PROPOSED DESIGN MAIN CANAL - Sibalaya

Gumbasa Irrigation Project

Project Preparation Consultant (PPC) Firm for
Development of the Gumbasa Irrigation System
and its Facilities, Palu and Sigi Districts, Central
Sulawesi Province.

January 2021

DENAH BENDUNG DENGAN BOULDER RACK OPSI-2

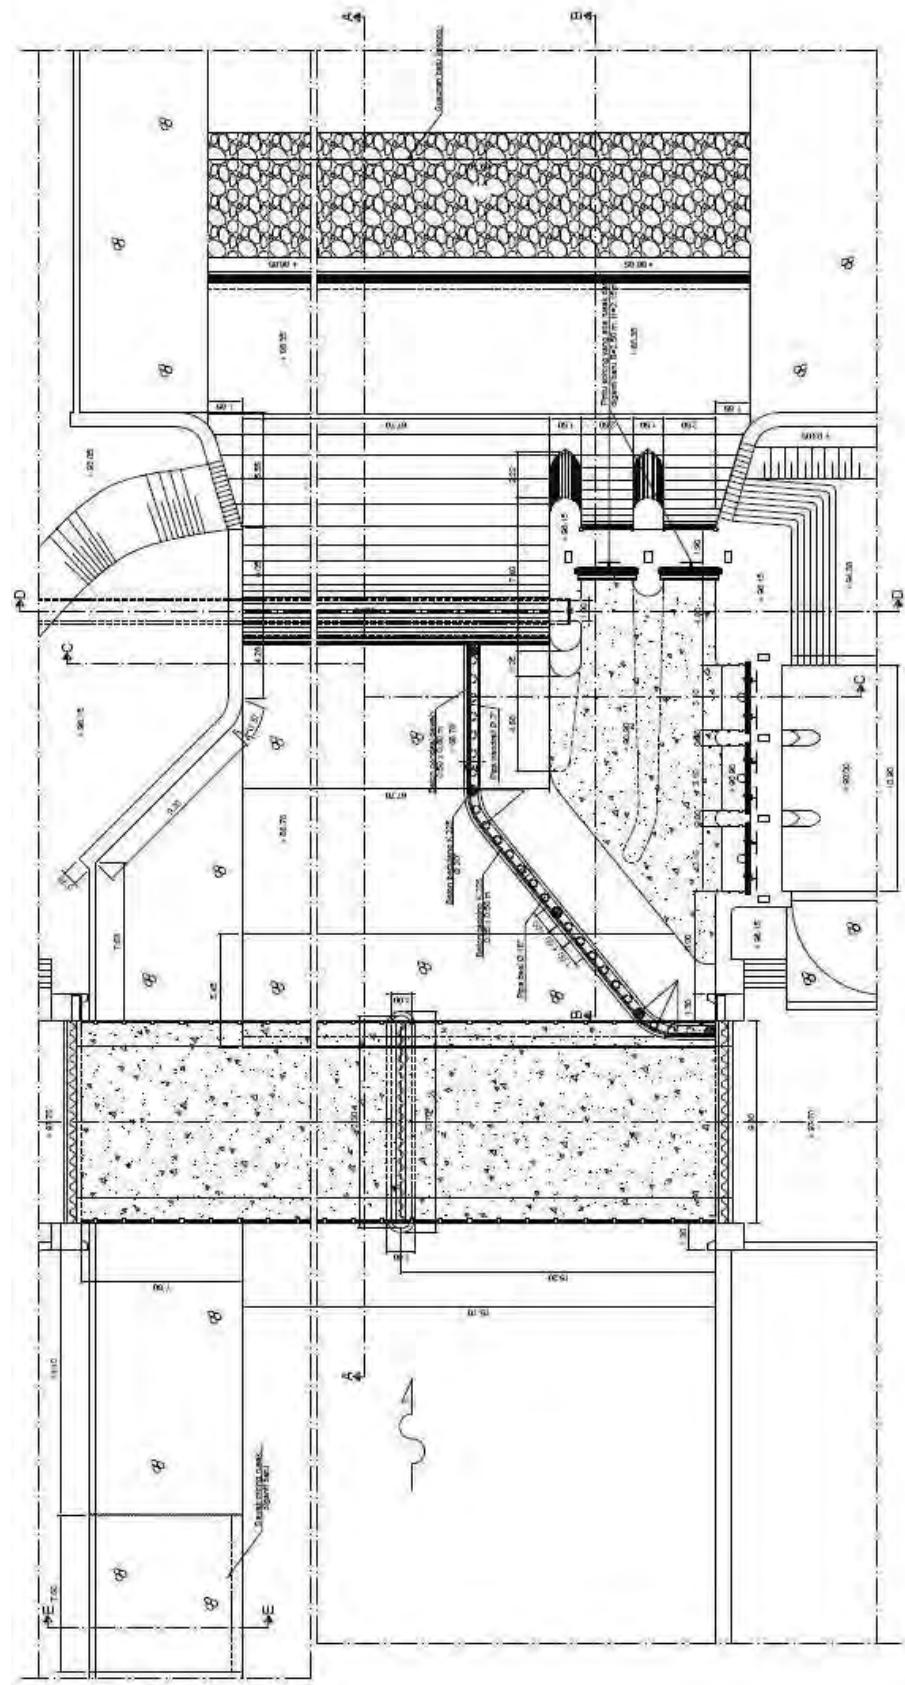
4. The embankment design must include access to the embankment.
5. Based on experience, it is necessary to have support (support column) or horizontal bracing, because otherwise, the construction will easily collapse (not strong enough). (Weir Plan with Boulder Rack Option-2)

- It will be fine if the flood level can still be raised until the bridge. But the concern is that if the Q1000 is taken then there is a part of the bridge that will be hit. So that the value taken is 97.2. The key that is suggested is maintenance. Must be in the OP.
- The embankment design must include access to the embankment.
- Checking the existing floor, for fear of cracks, it is necessary to make a water stock extension joint
- Based on experience, it is necessary to have a support column or horizontal barrier, otherwise, the construction will collapse (not strong enough). (Weir Plan with Boulder Rack Option-2)
- Agree to add the safety bar.
- Agree to have the reparation and cleaning.

Bolder Rack Structure

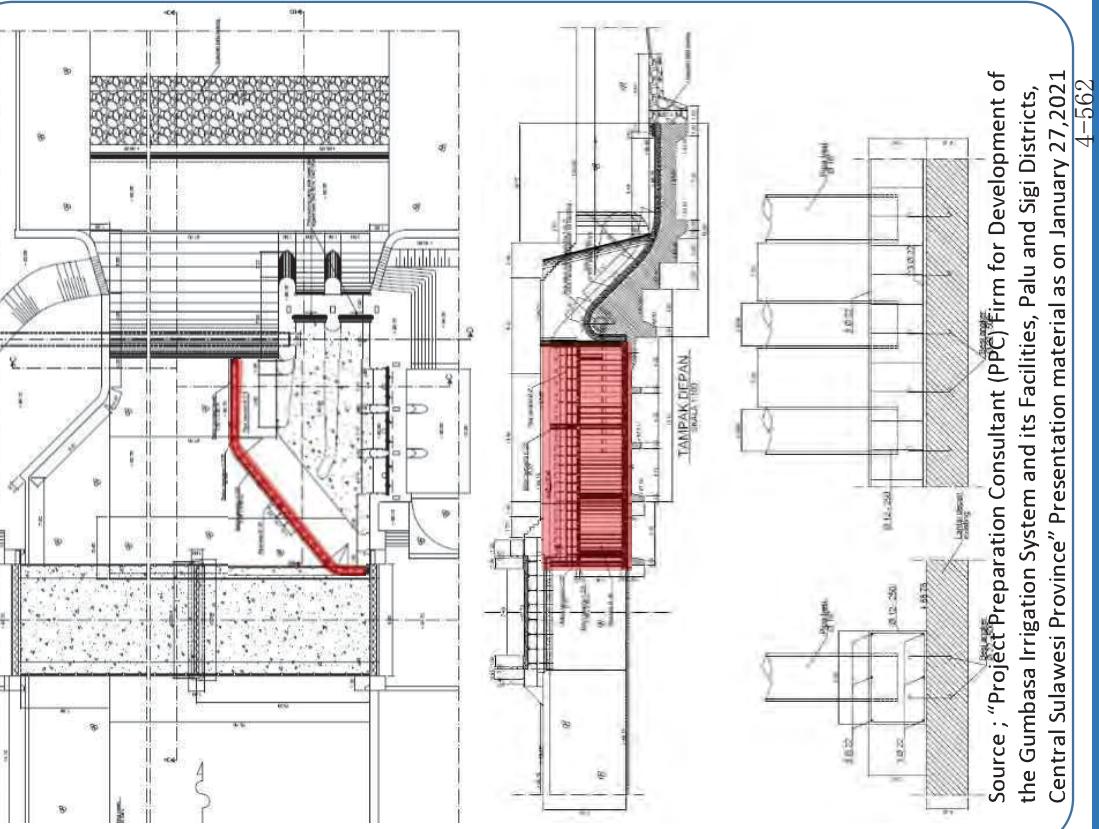
*However, it should be noted that sediment and gravel transported at normal flow rates cannot be captured by the sediment control facility on the upstream side.

A facility to capture earth and stone and driftwood will be installed on the upstream side of the bridge. A sediment control facility on the upstream side will be planned, and megaliths and trees will be captured at the sediment control facility. (Matters to be discussed with BWS-SII) The proposed facility plan does not need to be changed.

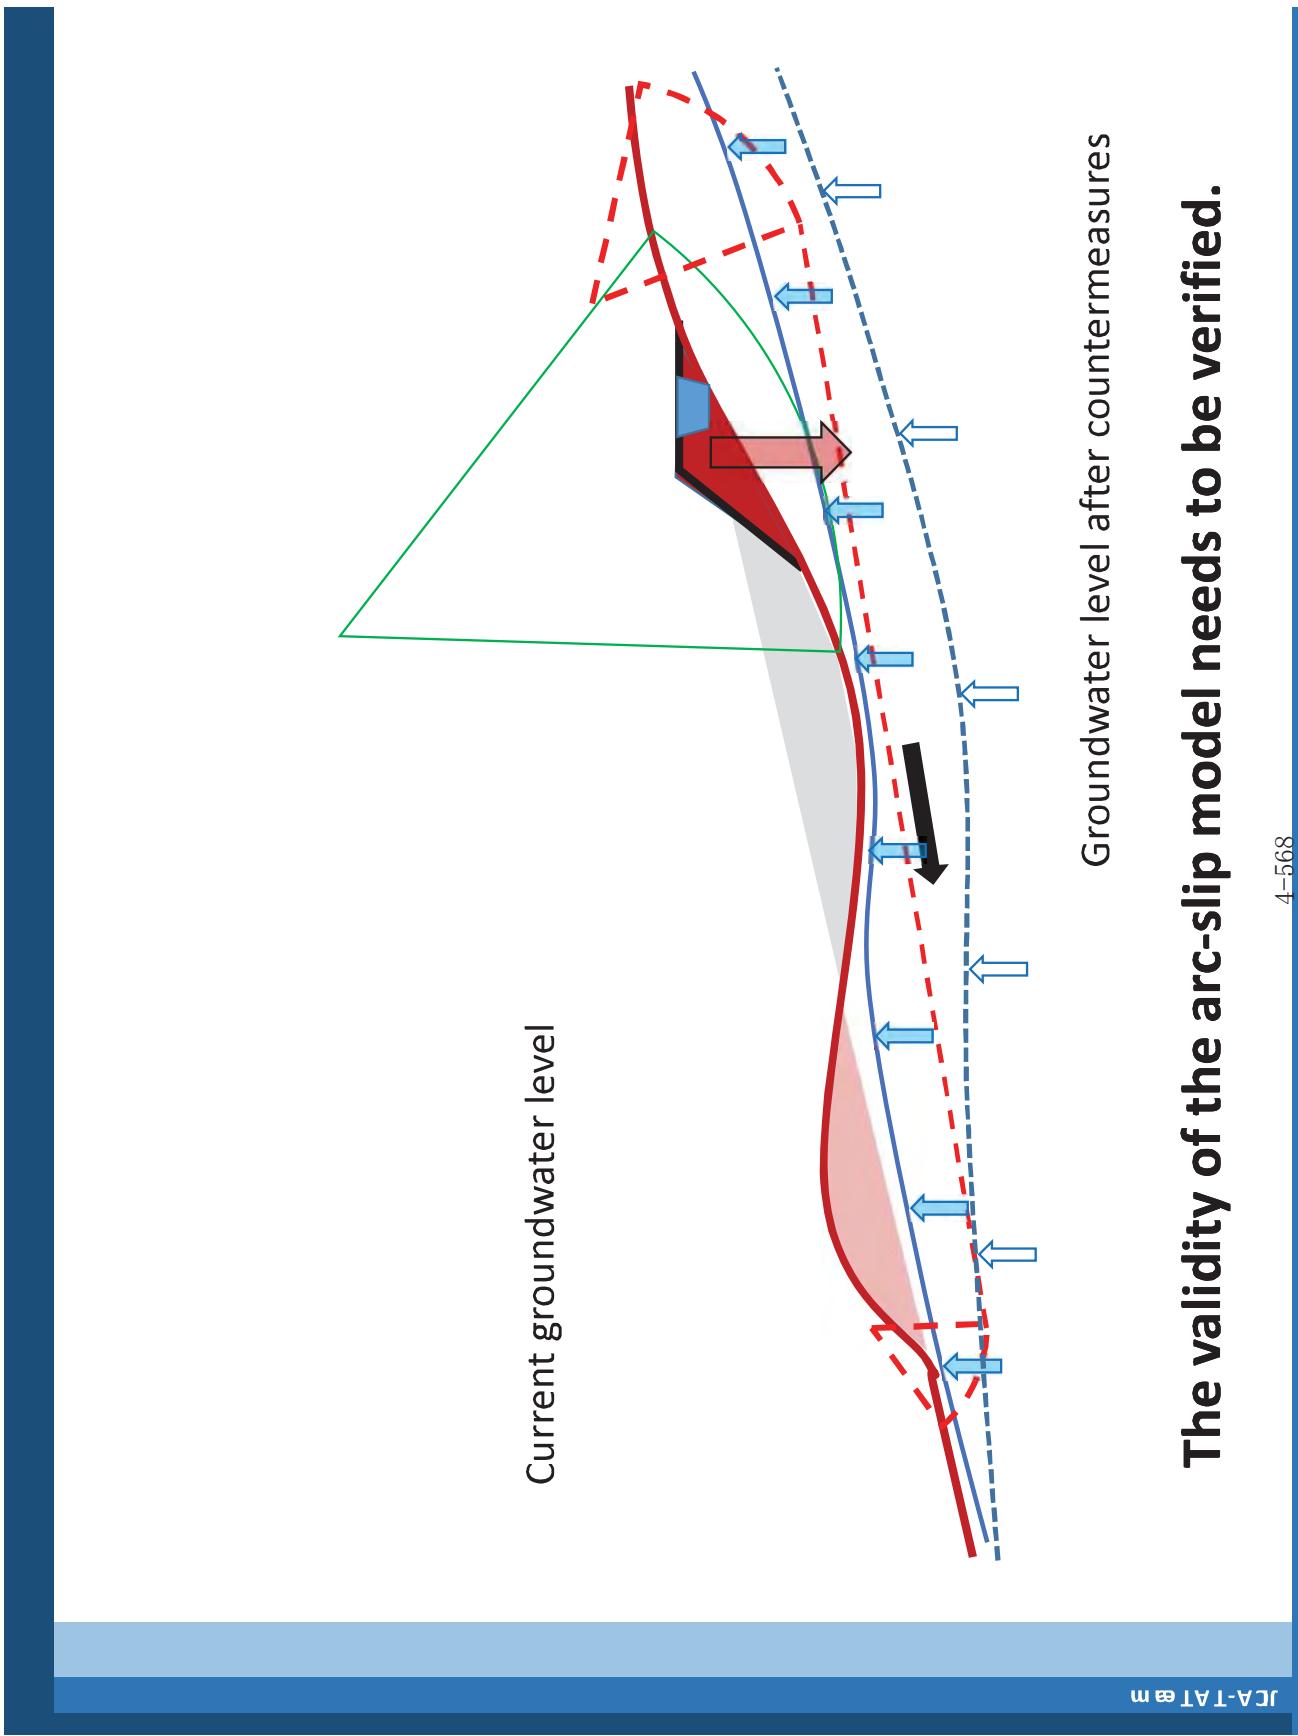
The Nalod (liquefaction landslide) phenomenon should be well understood and the geological composition and groundwater level should be modeled.

- The validity of the arc-slip model needs to be verified.
 - Load due to embankment
 - Possibility of water leakage from open channels
 - Setting of groundwater level
 - Consideration of groundwater pressure
 - Extent of liquefaction and strength of ground

Salua

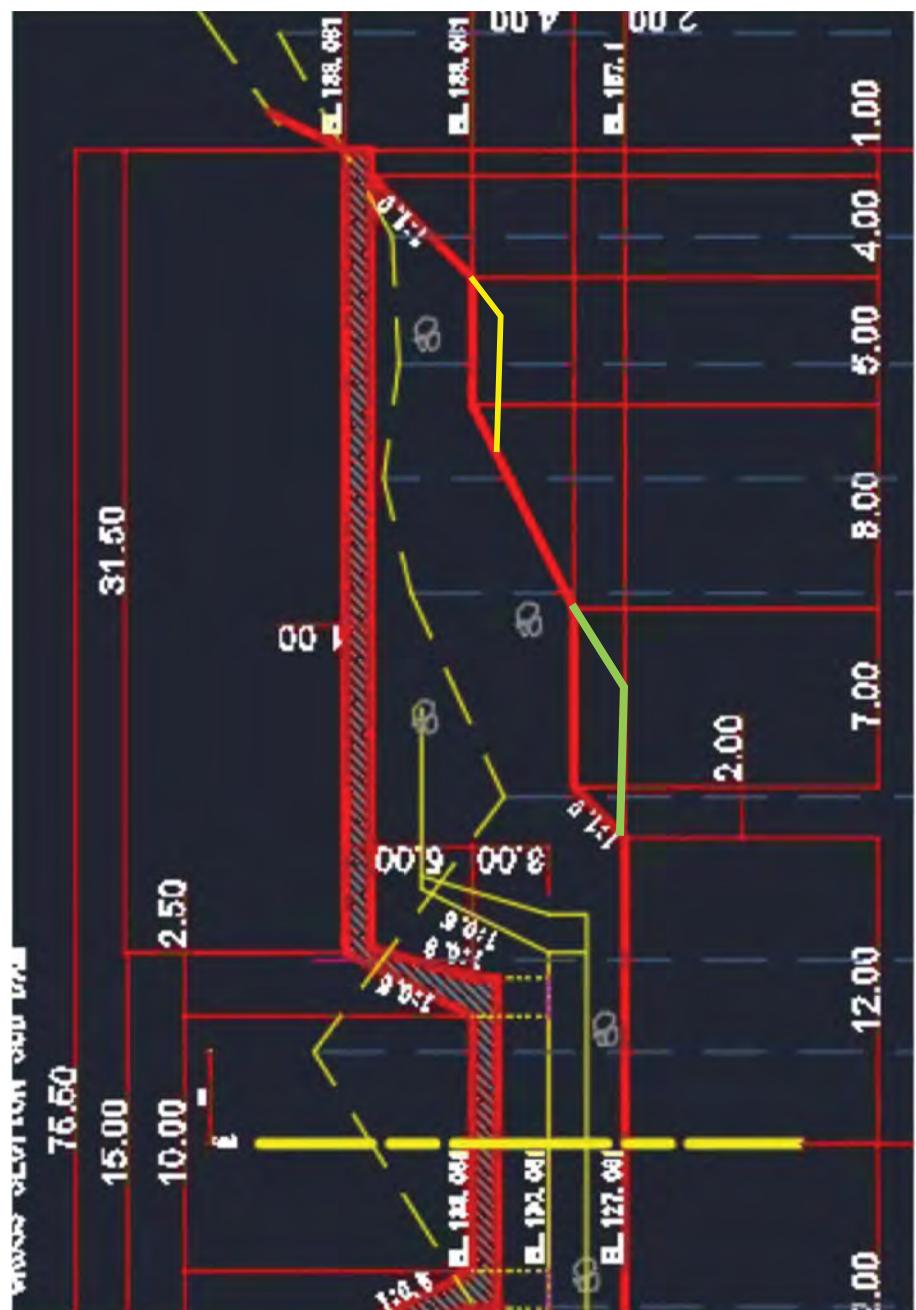
1. There are no floor plans or vertical profiles. I don't understand the whole thing.
2. The cross section is still a cross section seen from the upstream.
3. It must be corrected to the cross section seen from the downstream.
4. Basically, JICA-TA agree with the Sabo dam 1 and 2 structures proposed by the contractor.
5. Please explain the apron structure downstream of the sub-dam of Sabo Dam 1.

Paneki

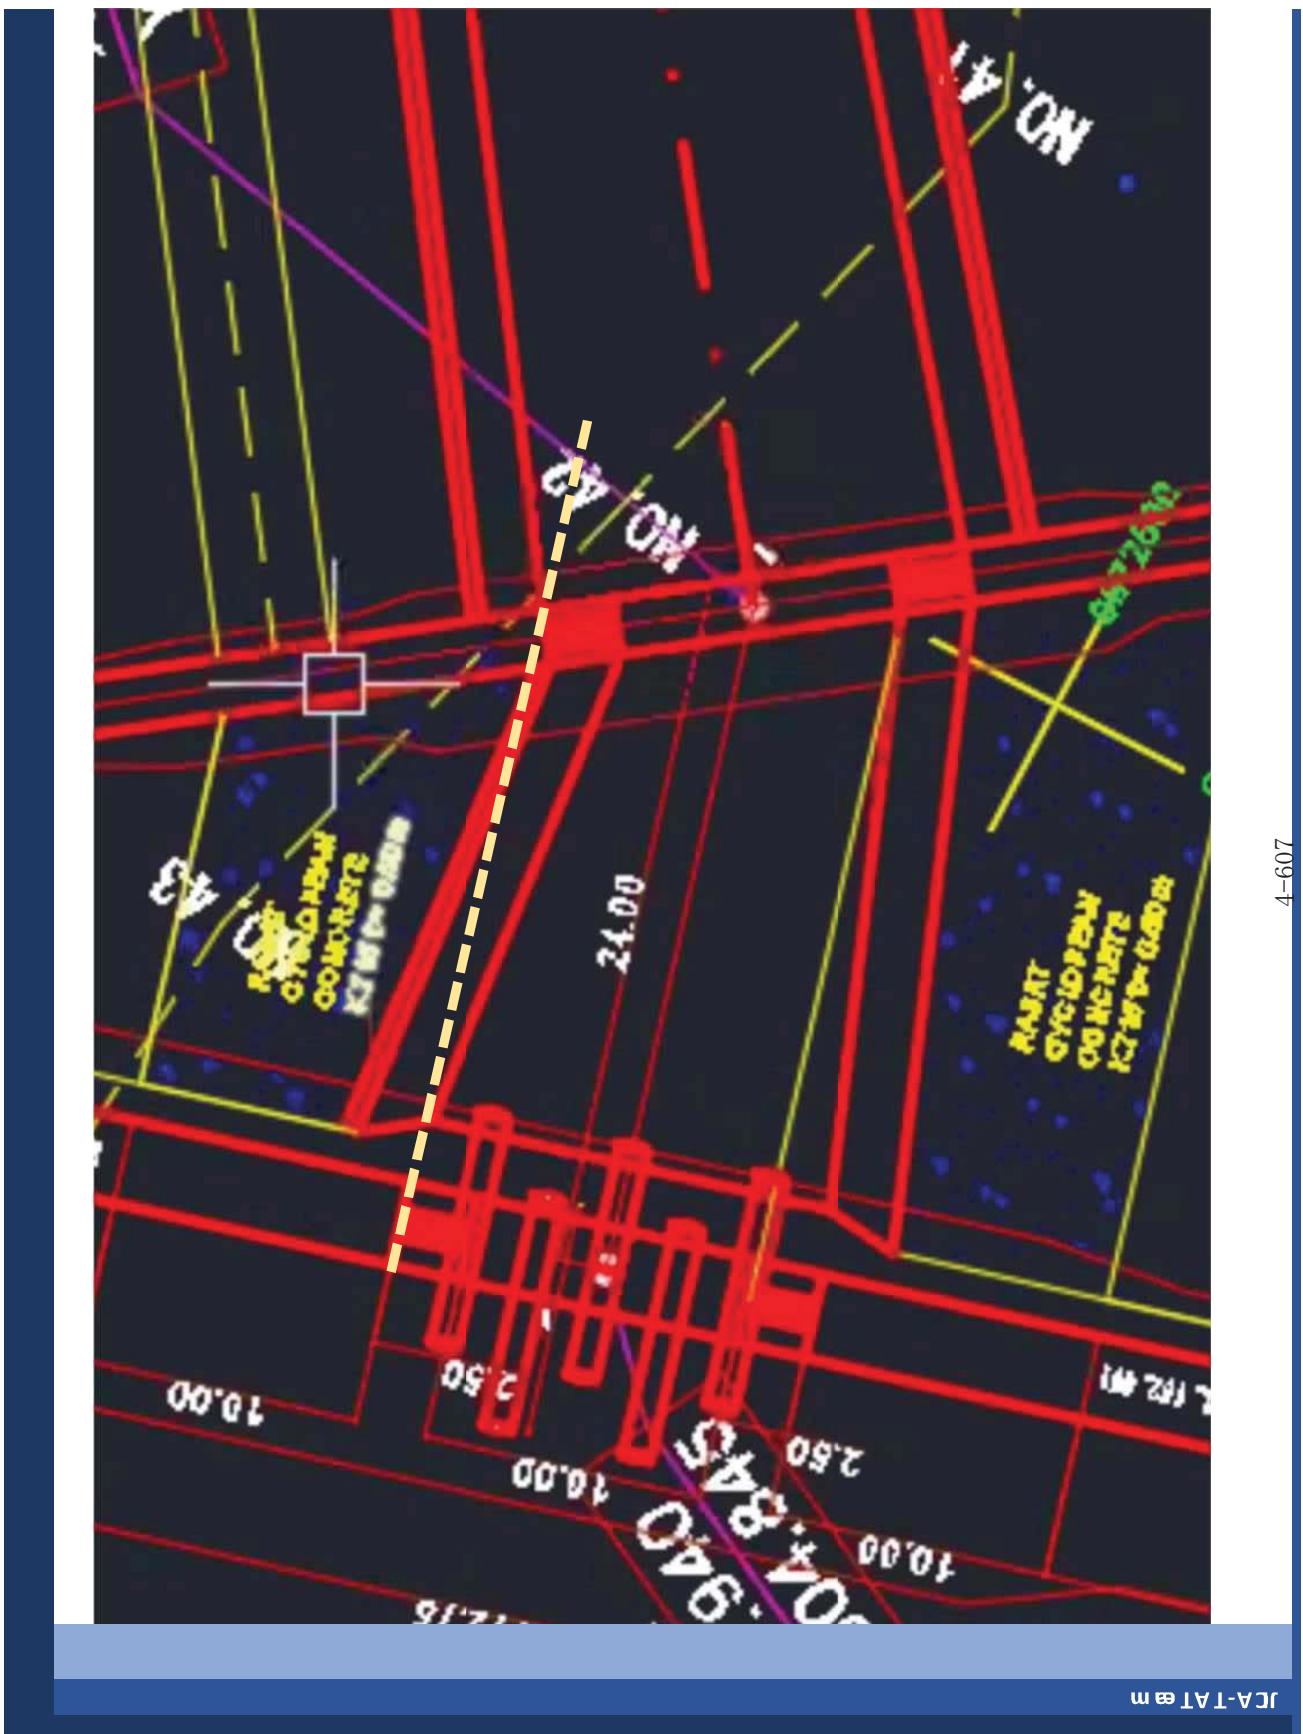
1. There was a proposal for additional structures.
2. JICA-TA is considering this.

Question c ; “Embankment Slope” and does it apply to all embankment structures?

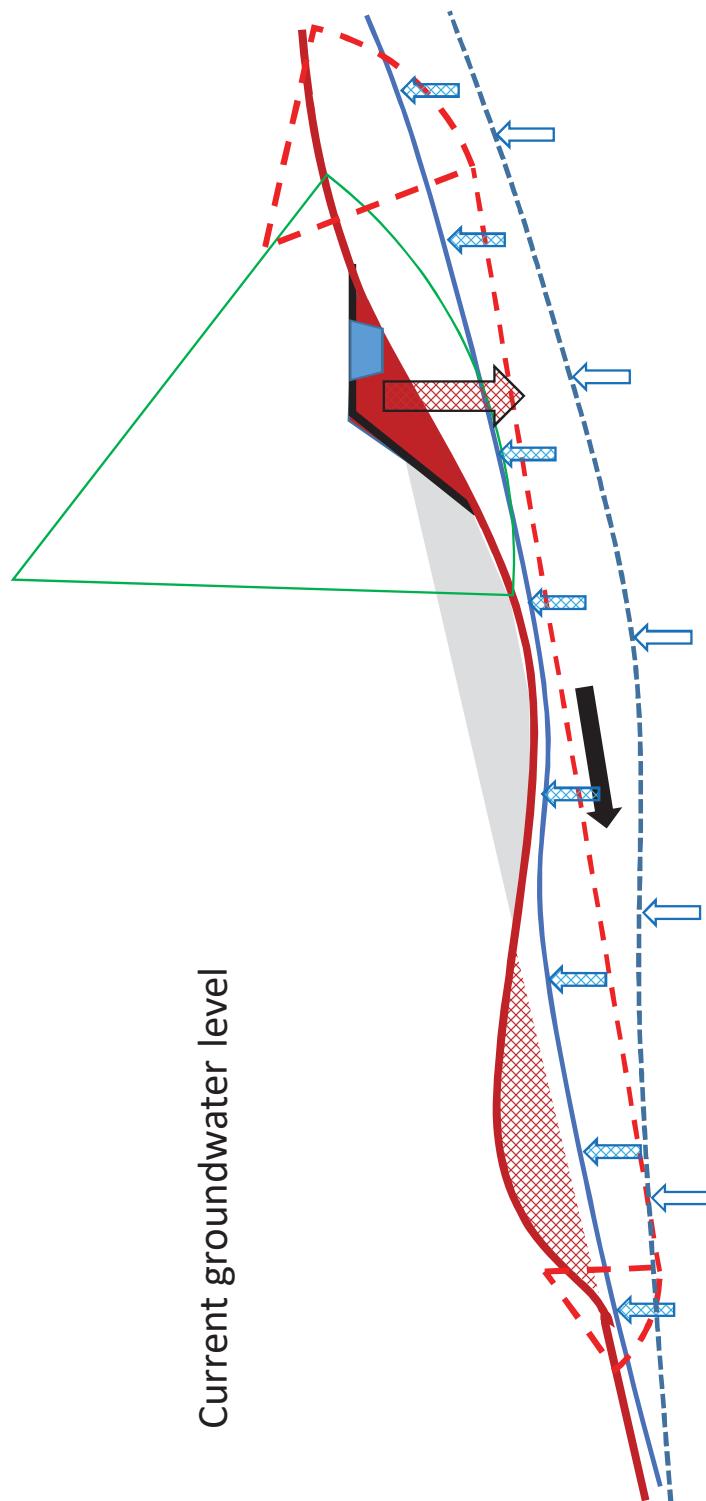
In Japan, where there are many earthquakes, as in Indonesia, if the target embankment slope height is 15 m or more, seismic force should be considered when examining the stability of the embankment. The reason is that it is large and there are many important facilities. In addition, at a height of 15 m or less, there are many cases where no major collapse has occurred due to an earthquake, and seismic force is not counted for stability calculation.

In the Sibalaya and Jono Oge areas, the foundation of the irrigation facility will be an embankment structure. The scale of the embankment tends to increase, and if it is positioned as an important structure, the proposed SLS-0.1125g seems to be sufficient. However, there is no need for design in ULS.
